AGENDA PACKET

JULY 21, 2020 MEETING

MEMORANDUM

RE: William McArthur & Alejandra Salazar
40 Old Pond Road
Sheet 33C, Block 11155, Lots 16, 17 & 44

PROPOSED SITE PLAN
1"= 10'

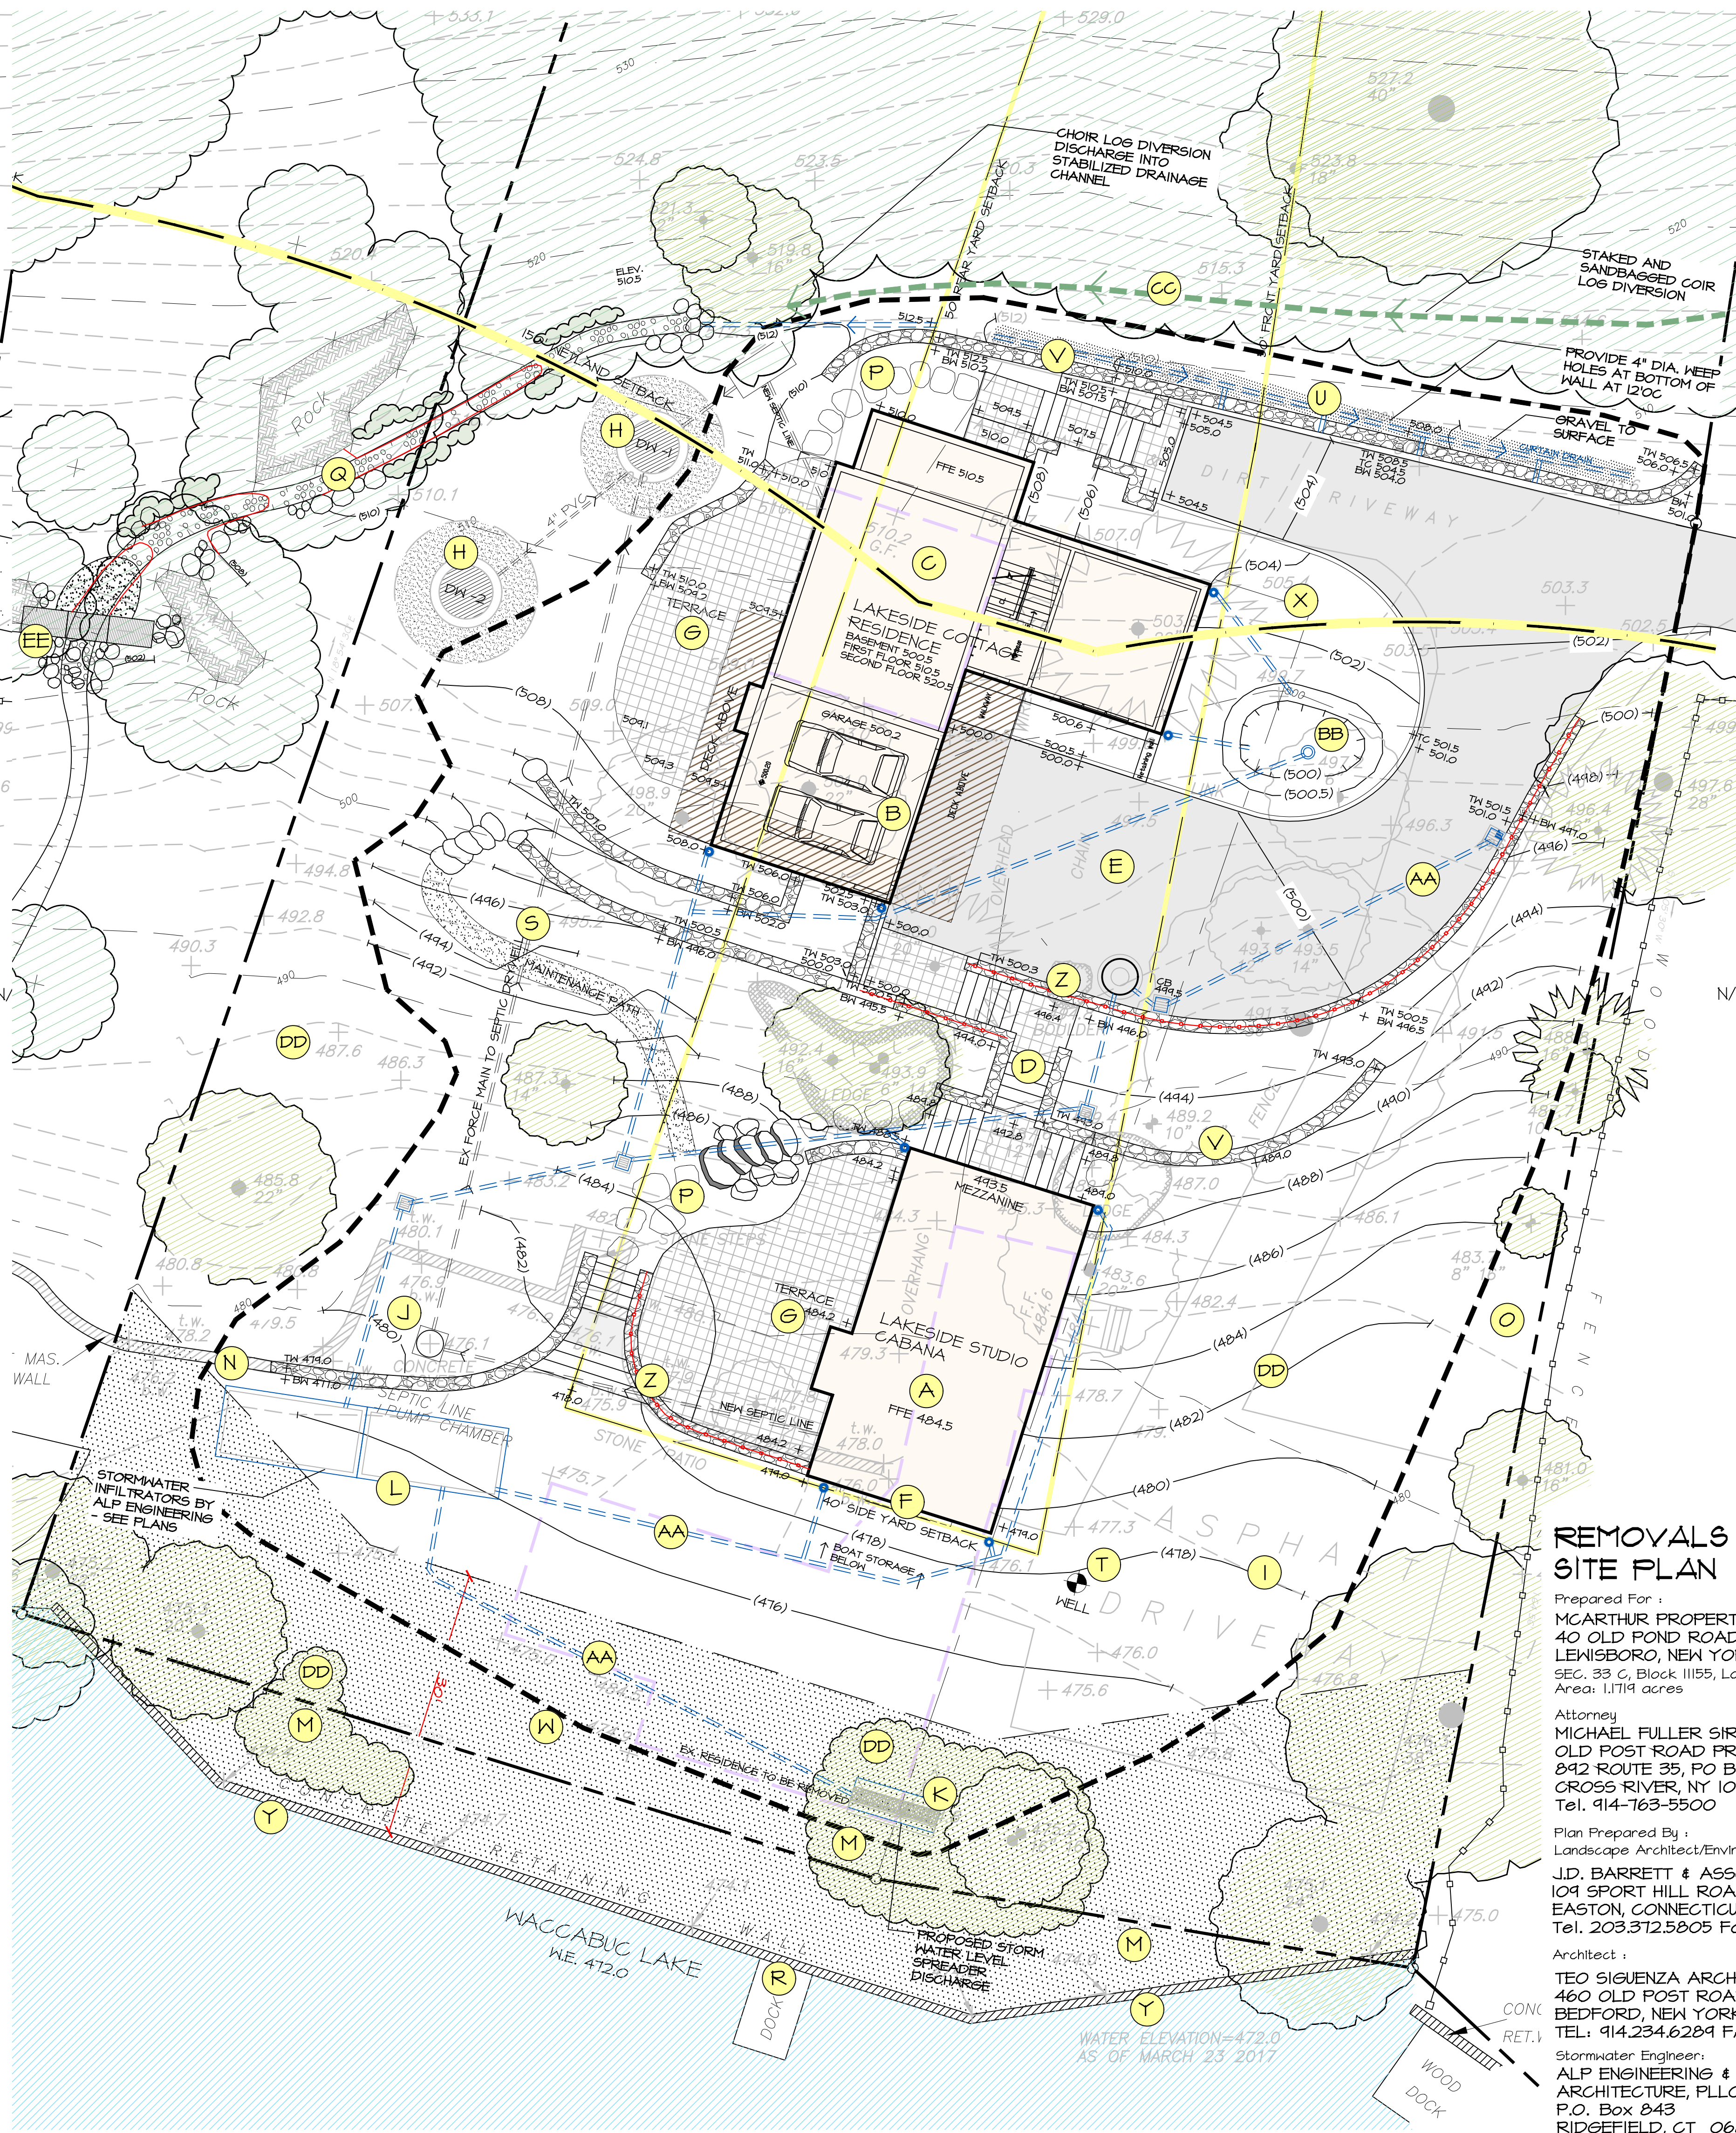
12. The FEMA floodplain map has been provided on Sheet 4 of 5. The boundary limit and base flood elevation of the 100-year FEMA floodplain shall be illustrated on the Site Plan.

13. As previously requested, provide all applicable construction details including, but not limited to the driveway, retaining wall, curtain drain, plantings, and drainage.

14. The plans shall illustrate and quantify the limits of disturbance. The plan shall note that the limit of disturbance shall be staked in the field prior to construction.

17. As per the NYSDEC Stormwater Design Manual, infiltration practices shall be installed in virgin soils and cannot be installed on slopes greater than 15%. The proposed rain garden is located on slopes greater than 15%; the plan shall be revised accordingly.

We have added flood plain information to Sheet 3 of 5. The information was sourced from the FEMA website.

Stormwater Management Plan

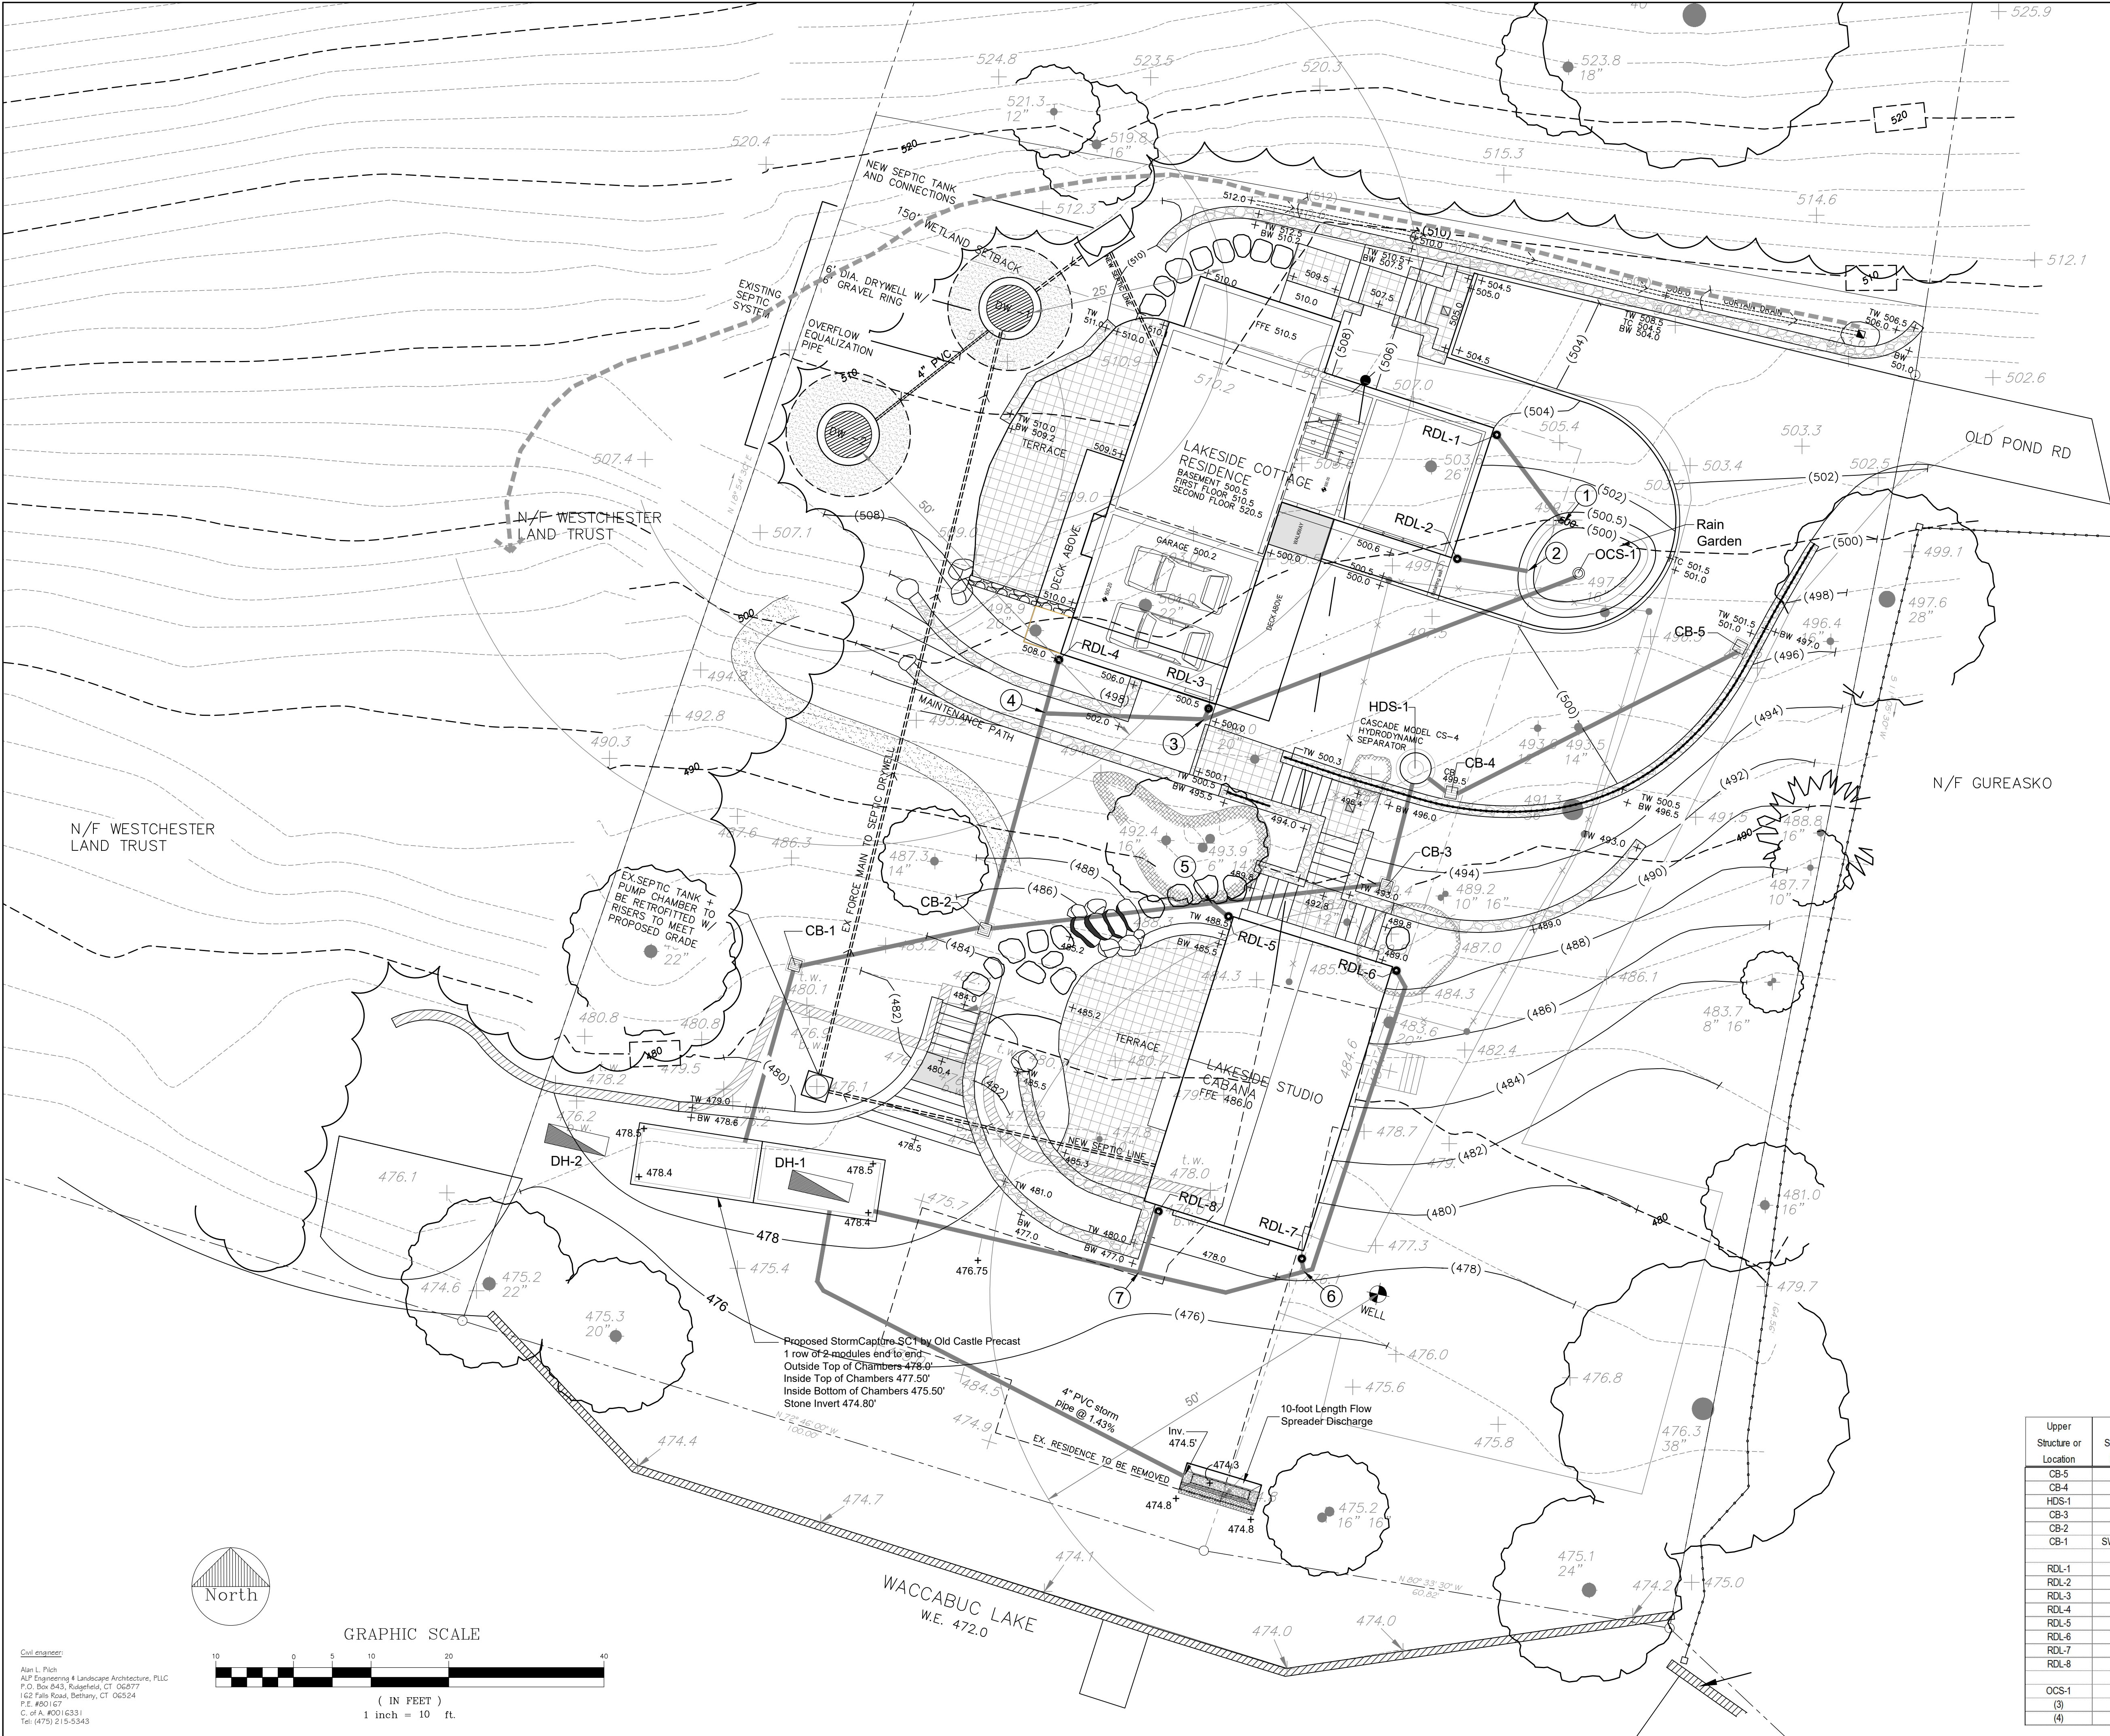
15. The stormwater calculations provided indicate that an infiltration rate of two (2) inches/hour was used when designing the raingarden. Testing is required to confirm the infiltration rate, which shall be witnessed by this office. All soil test results shall be noted on the stormwater plans.

19. The plan shall demonstrate that all required WCDH setbacks and separation distances associated with existing septic, well and drainage structures have been maintained, including the proposed curtain drain.

Deep hole testing was performed on the property on June 17, 2020 and the testing was witnessed by the Town's Engineering Consultant and the New York City Department of Environmental Conservation. Two deep hole test pits were dug, labeled on the plans as Deep Hole Test #1 and #2 (see drawing C-101).

Response: Drawing C-101 depicts the 25-foot and 50-foot offsets from the existing septic system. In accordance with the health department requirements, no piped drainage is shown within 25 of the septic system.

In addition, the 50-foot setback is depicted from the existing well. In accordance with Part 5, Subpart 5-1 Standards for Water Wells - Appendix 5B, a surface wastewater recharge absorption system with no automotive related wastes (such as roof drain leaders) must be at least 50 feet from a well. The proposed rain garden is about 90 feet from the well. Driveway runoff is not proposed to discharged to an absorption system; rather, it will be treated in a hydrodynamic separator; flows from the developed portions of the site will be captured in a StormCapture SC1 facility which will provide peak rate attenuation from the flows.
